Our Ref: 11584--1

RE: DA22/0417 – Response to RFI - Supporting information

Property: 158-164 Old Bathurst Road, Emu Plains

Figure 1 Proposed section of Road on the Site's eastern boundary

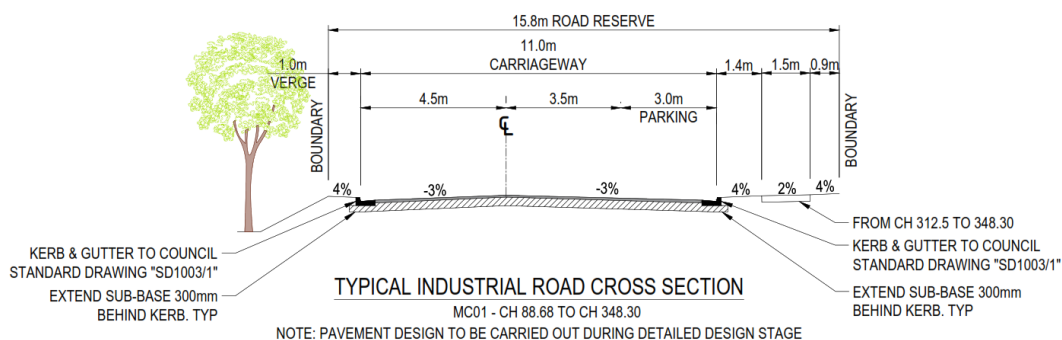
The Civil Engineering package has been amended to reflect the new layout, further reduce the amount of cut and fill to retain additional trees, incorporate splay corners, refine the wetland infrastructure design, realign the intersection of David Road and Old Bathurst Road and accommodate footpaths along the Old Bathurst Road and David Road frontages.

In relation to the retention of trees, the project Civil Engineers, ACOR have worked closely with project Arborists (Civica) and Landscape Architect (Group GSA) to deliver a unique road reserve solution along the eastern Site boundary, that will accommodate the carriageway and stormwater whilst maintaining and enhancing a treed corridor (see **Figure 1**). The batter up to the carriageway as well as quantity of water that enters this location has been considered for future survival of the existing trees. This represents a departure from the standard industrial road geometry but was developed with input and feedback from Council and despite the departure, the ability to accommodate the retention of existing trees in the industrial landscape is an overall positive outcome.

Figure 2 Section of Road Reserve adjoining the eastern site boundary

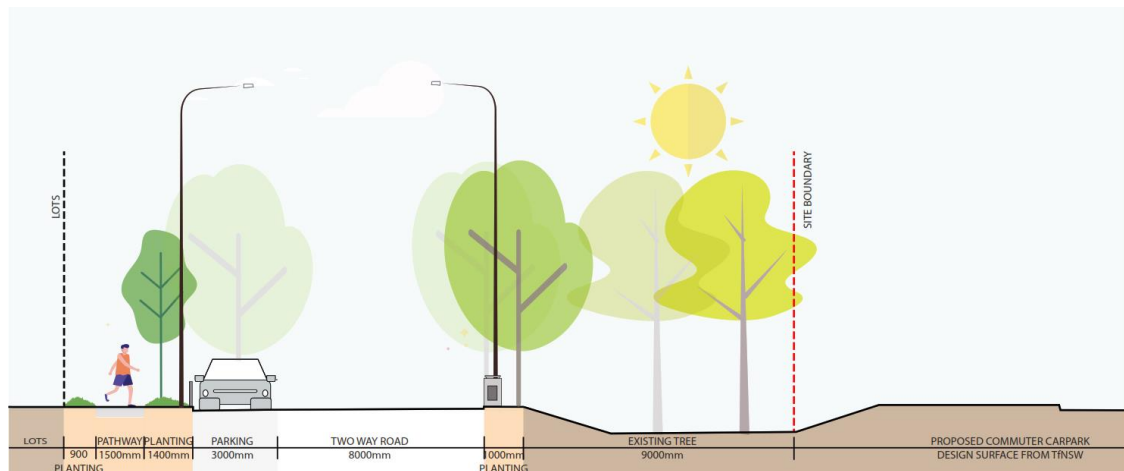
In accordance with Council's Urban Heat Management Chapter in the DCP, the development includes street tree planting every 8m. The choice of tree species has given preference to those known to be foraging trees for the Swift Parrot (*Lathamus discolor*) as informed by the Biodiversity Development Assessment Report (**BDAR**) in **Appendix G**. To further support the Swift Parrot, the development has retained and enhanced the vegetation along the eastern boundary, where it adjoins the Transport for NSW commuter car park. The delivery of the car park has removed the majority of the mapped Swift Parrot habitat, however the revised subdivision plan will retain the

remaining vegetation through delivery of a modified road reserve located along the eastern site boundary (see **Figure 2**).

Figure 8 Snapshot of Tree Retention Value Mapping

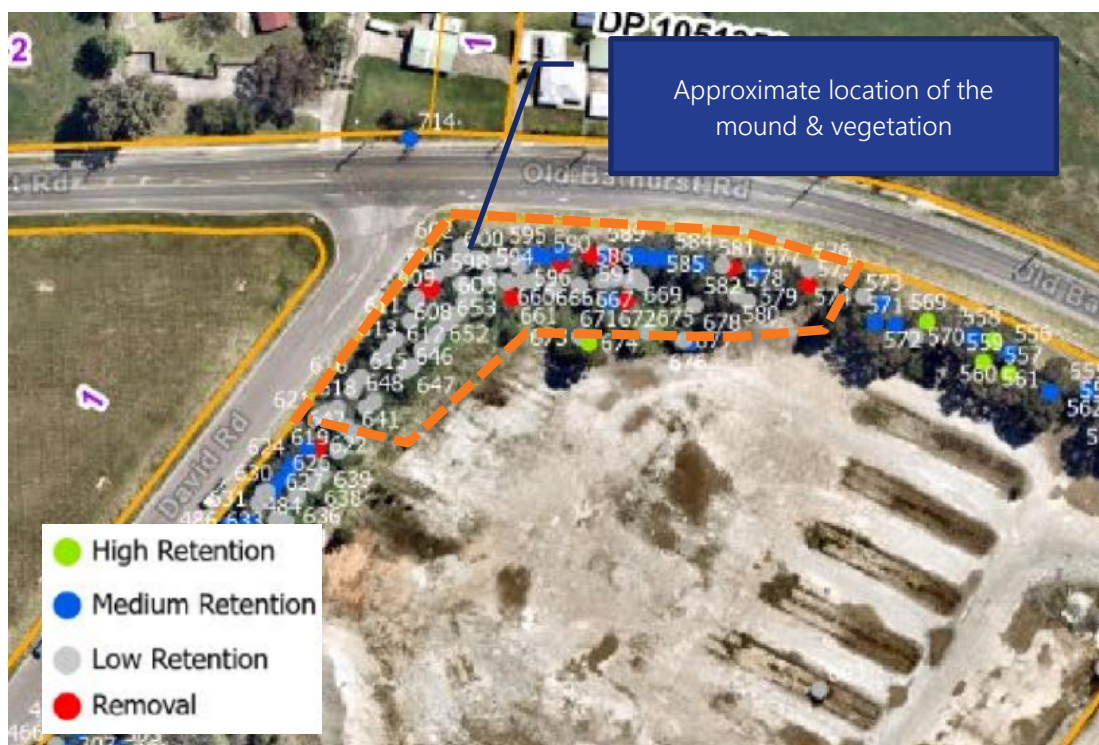
The Arborist Report in **Attachment E** identifies most of this vegetation as low value or for removal. Only a handful of trees are identified as medium retention value and one as high retention value (see **Figure 8**). The replacement planting will provide a much greater concentration of native species. Considering the mounds appear to have been constructed by just pushing the ground up against the edge of the Site, there is potential for these mounds to contain contamination, for which the Applicant is undertaking testing to supplement the Phase 2 investigations under the Remediation Action Plan.
